ADDENDUM ONE

Project: Sullivan County Heights Middle School Tennis Court Resurfacing Address: 1236 Moreland Drive, Kingsport, TN

February 28, 2024

2/27/2024 1:35:45 PM file: C-100 LAYOUT PLAN

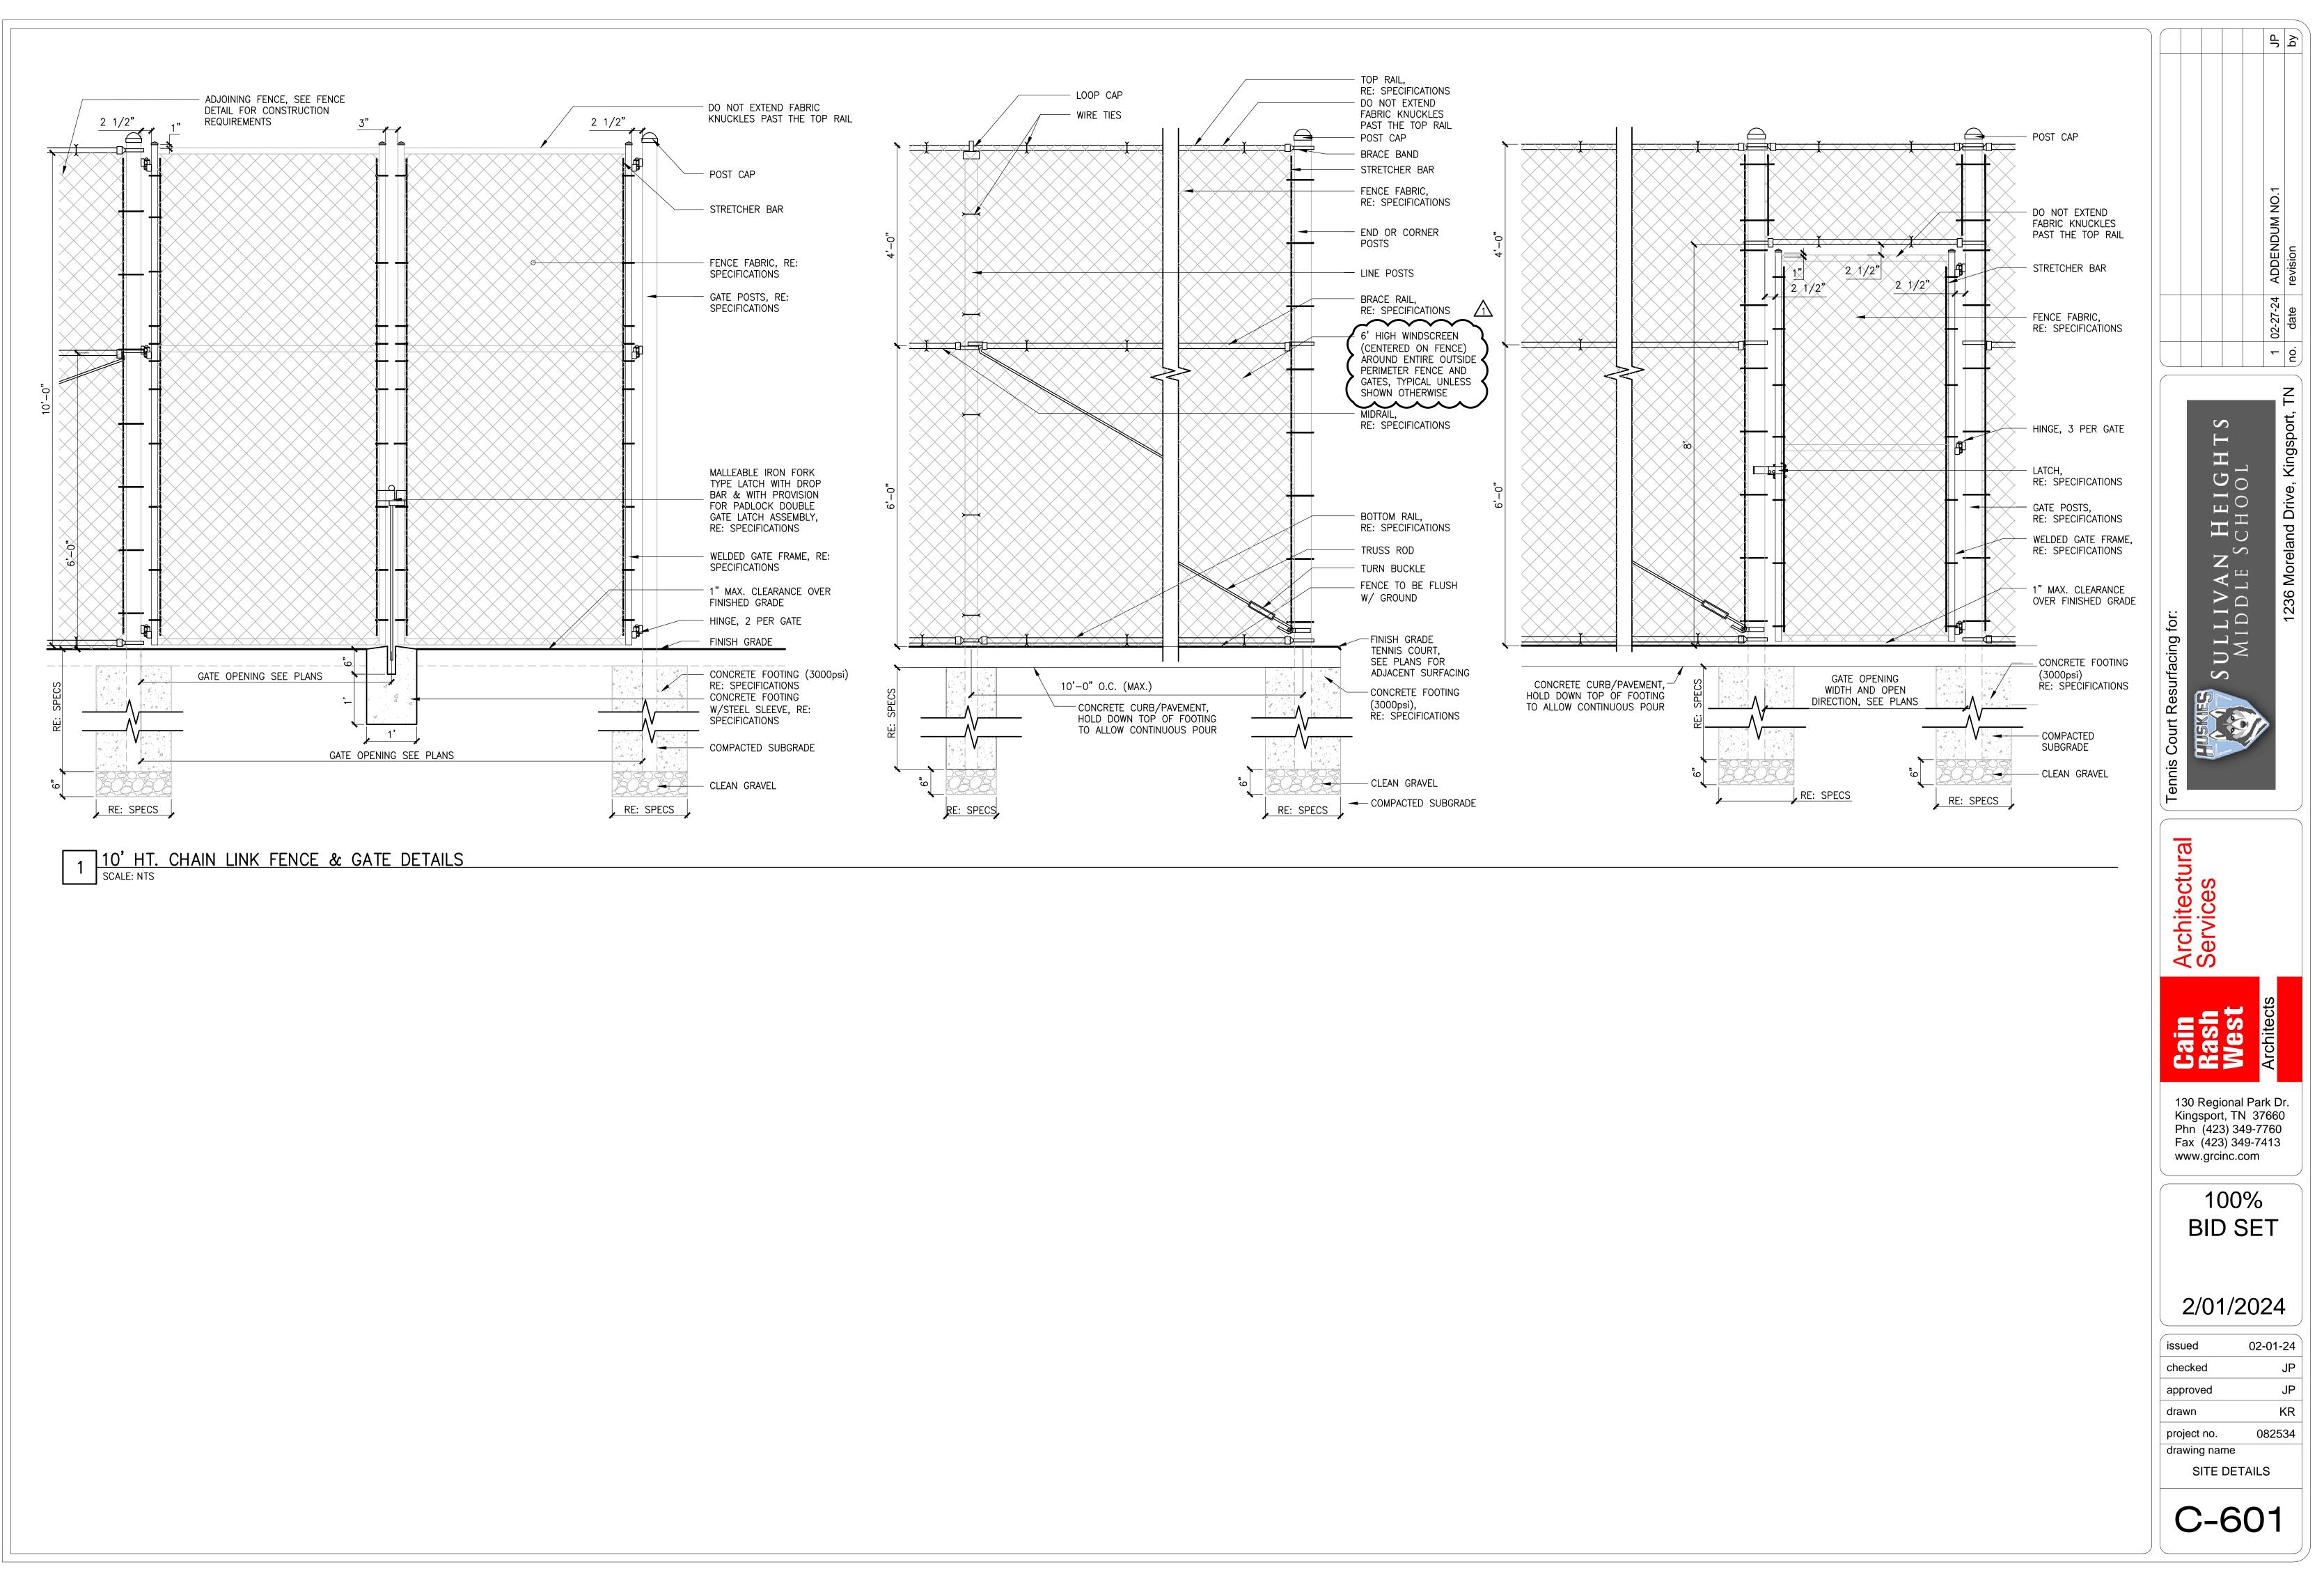
- 5. Alternate schedule calls for removal of 8 tennis net post bases. There are 12. Answer: The alternates specification section should be removed in its entirety from the project manual. There are no alternates as part of this project. The 12 existing tennis net posts should be removed and replaced as per the plans in the base bid.
- 6. Do you want to paint the light poles at least a few feet up? Answer: There is no need to paint the existing light poles at this time.
- 7. Will you consider changing windscreen to 6' Dura-Air by Putterman? Answer: Yes, 6' high windscreen is acceptable. Please see attached revised Outdoor Sports Equipment specification section and plans as part of this addendum.

- 1. DRAWING C-100
- 2. DRAWING C-601
